# REGIONAL REVIEW NOTICE

ARC REVIEW CODE: R1303141

**Name of Proposal:** Prominence at Buckhead

**SUBJECT:** **Transportation Division Review of DRI # 2329**  
Project: Prominence at Buckhead  
County: Fulton  
Location: 3475 Piedmont Road, Atlanta, GA 30305  
Analysis: Expedited ☐  
Non-Expedited ☒

**City of Atlanta Concerns:**

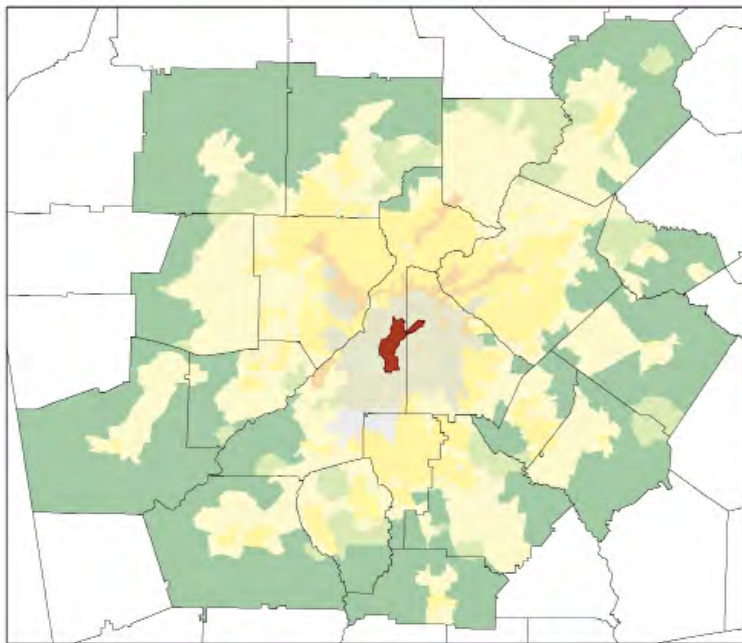
- Joshua Mello, from the City of Atlanta, expressed concern about the site's interaction with Piedmont Road. He requests full public access to the traffic signal on Piedmont Road north of the site, and to remove the existing right-in/right-out driveway on Piedmont, citing pedestrian safety concerns. Mello also requests bus stop amenities in front of site on Piedmont Road.
- There are concerns about Lenox Road as well. Mello requests the removal of channelized right-turn from Lenox Road driveway, citing pedestrian safety concerns and the addition of the GA 400 Greenway Trail which will increase pedestrian traffic.
- The intersection of Piedmont Road and Lenox Road will need improvements to address pedestrian safety, and accommodating safe access between the site and both MARTA and Buckhead retail.

- The existing poor level of service at Piedmont Road and Lenox Road was discussed during the pre-review meeting, and the need to study the intersection for solutions to traffic flow problems.
- Additionally, the zoning change to SPI-12 suggests a greater focus of the area on pedestrian-friendly mixed-use development. Pedestrian safety at Piedmont Road and Lenox Road are of concern and improvements to the intersection that address pedestrian safety should be studied since this is a major linkage between the subject site, major retail, and MARTA rail.
